FIGUEROA STREET BUSINESS PARK PROJECT

INITIAL STUDY/MITIGATED NEGATIVE DECLARATION

**FINAL
INITIAL STUDY/MITIGATED NEGATIVE DECLARATION**

2.0 RESPONSE TO COMMENTS

- Exhibit 2-4 Conceptual Site Plan

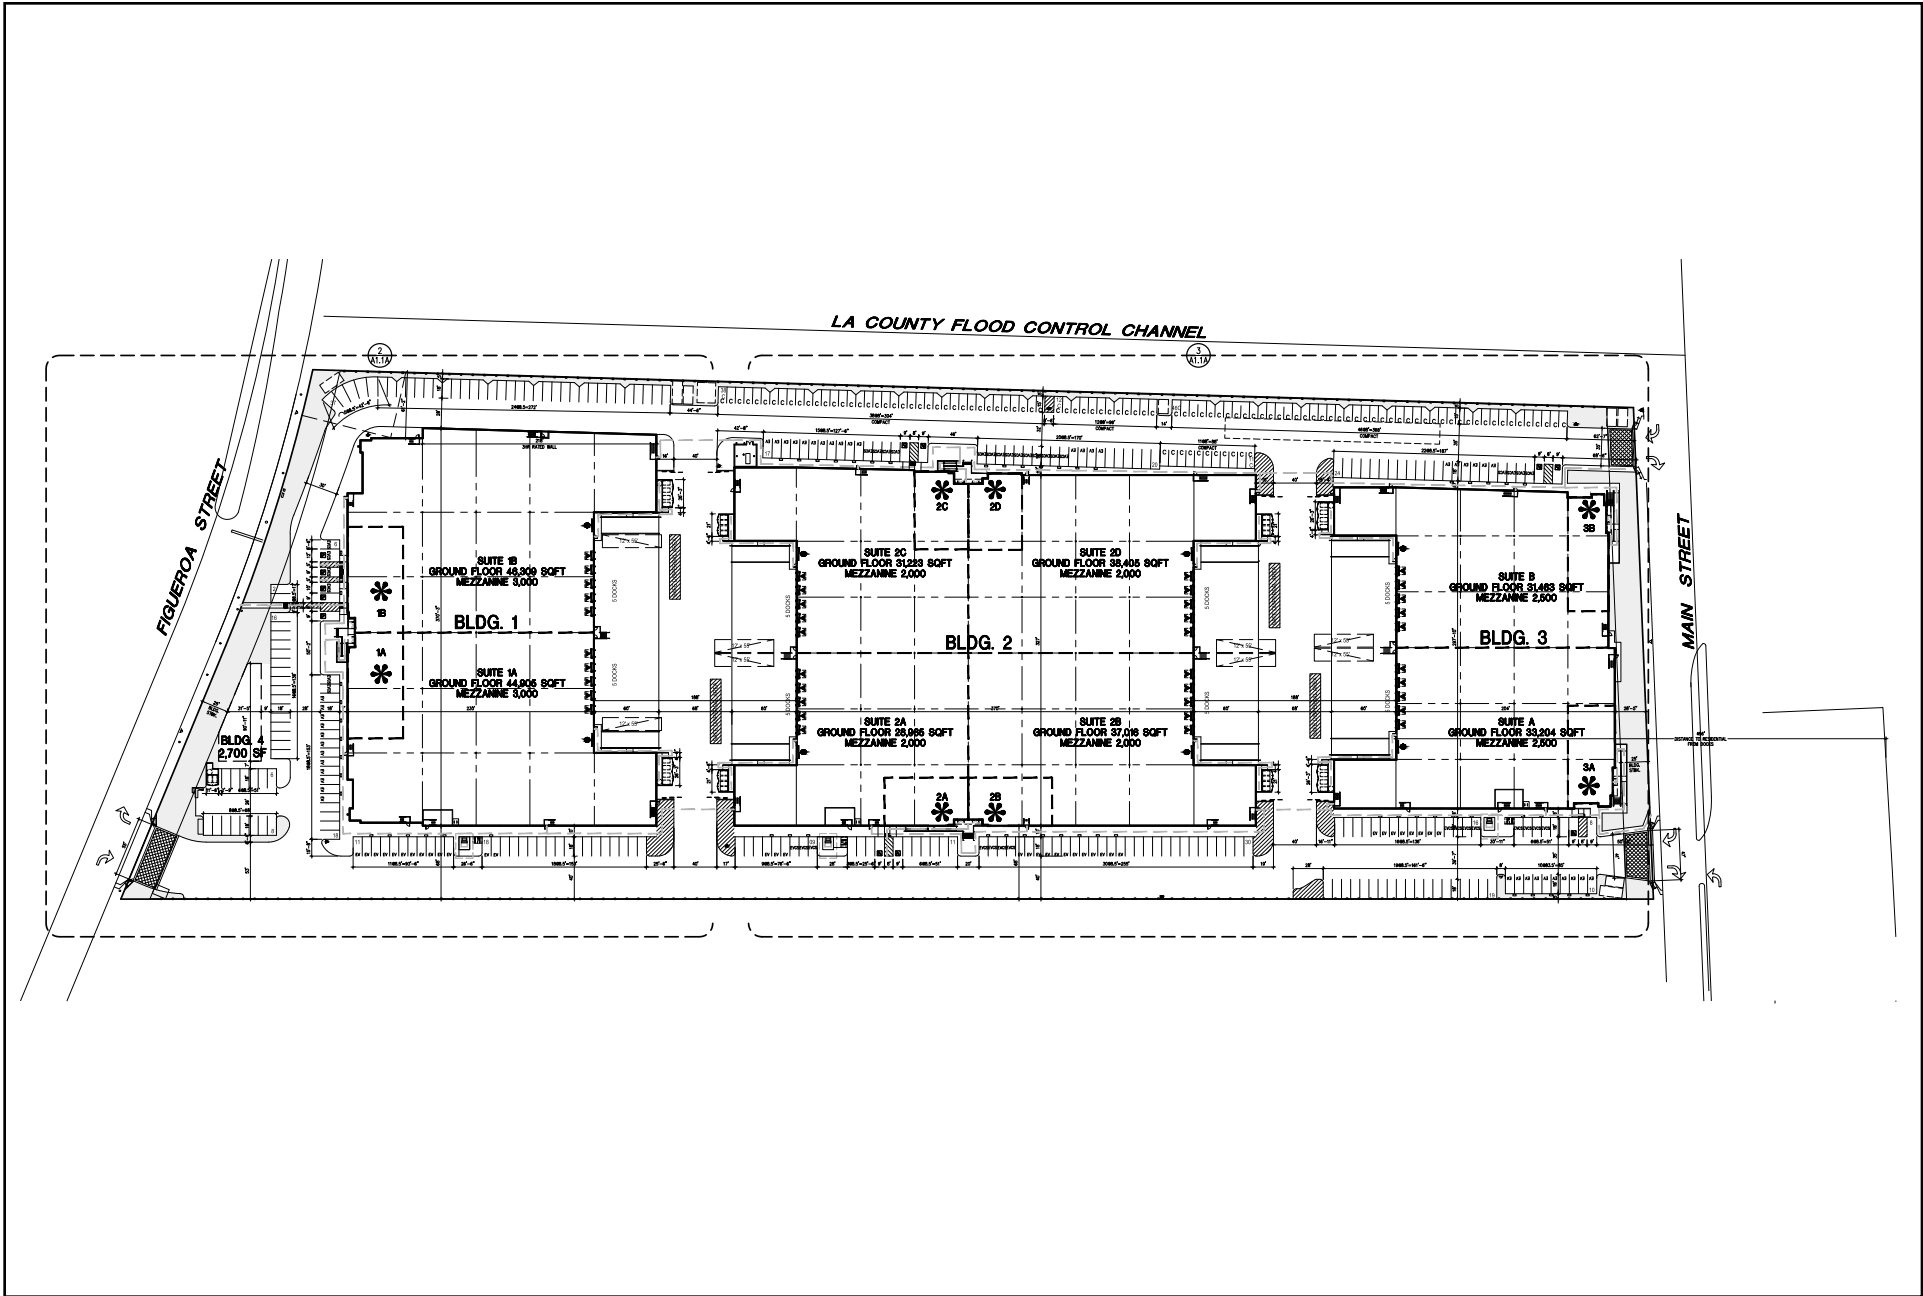
- 3-4 The commenter states that Exhibit 2-4, *Conceptual Site Plan* on page 2-10 of the Draft IS/MND removes pertinent information from public view regarding earthwork quantity notes, parking requirements, or maximum building height. Although Draft IS/MND Exhibit 2-4 does not depict information regarding earthwork quantity notes, parking requirements, or maximum building height, the project description of the Draft IS/MND provides pertinent information regarding earthwork and construction activities on Draft IS/MND Section 2.5, *Phasing/Construction*. Further, a discussion of maximum building heights is indicated on Tables 2-4 and 2-5 on page 2-14, indicating no maximum building height is applicable for Planning Area 1 and a maximum building height limit of 30 feet applies for Planning Area 2, respectively. Lastly, parking requirements are depicted in Draft IS/MND Table 2-6, *Parking* for both Planning Areas 1 and 2. As such, the Draft IS/MND adequately discloses pertinent information regarding earthwork quantity notes, parking requirements, and maximum building heights of the proposed project in this regard.

As shown in [Table 2-1](#), the total building square footage on-site was slightly reduced by 76 feet from 313,266 square feet to 313,190 square feet. The proposed modified project would provide an additional two dock doors, five grade doors, and two trailer stalls for increased truck loading/unloading efficiency. Vehicular parking would be reduced by a total of six parking stalls. Based on the proposed design modifications, three electrical rooms, two bicycle storage rooms (accommodating two bicycles per room), and two trash receptacles would be removed. Additionally, the maximum building height for Planning Area 1 would be reduced by six feet to reduce massing on-site. With a decrease in the total building area on-site, the proposed modified project would accommodate 144 square feet of additional landscaped areas. The building spacing would also be modified from 120 feet to 68 feet between Building 1 and Building 2 (a total reduction of 52 feet), 51 feet to 68 feet between Building 2 and Building 3 (a total increase of 17 feet), and 80 feet to 77 feet between Building 4 and Building 1 (a total reduction of 3 feet). Lastly, the setback along the northern site perimeter would decrease by one foot and the setback along the southern site perimeter would increase by eight feet.

5 SHRUB/TREE DETAIL OVER LANDFILL, TYP.
SCALE: NOT TO SCALE

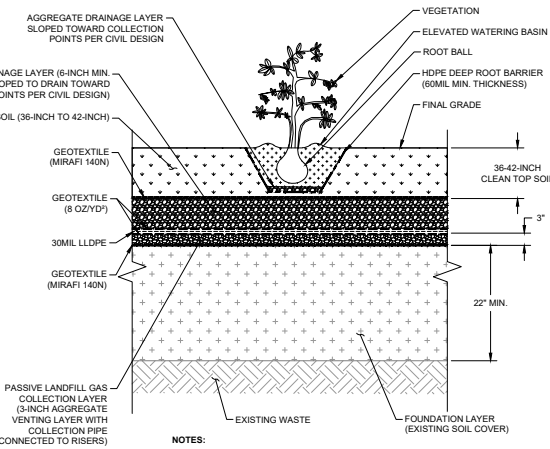
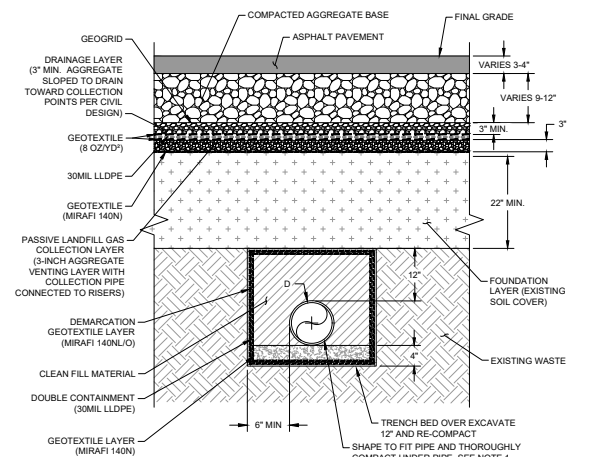
- 5-19 The commenter notes that the proposed tree wells as shown on Draft IS/MND Exhibit 2-3b are relatively small and appear unlikely to support the proposed tree sizes and density as shown on the cover of the Draft IS/MND. This comment is acknowledged; however, it does not raise issues pertinent to the adequacy of the Draft IS/MND. Nonetheless, it should be noted that the images provided on the cover are conceptual renderings of the project and are subject to change during the design phase. Additionally, it should be noted that tree well design would accommodate the rooting depth for the proposed landscape trees and shrubs. Environmental design documentation will be provided to the City of Carson and all responsible agencies, including DTSC, for review and approval prior to implementation.
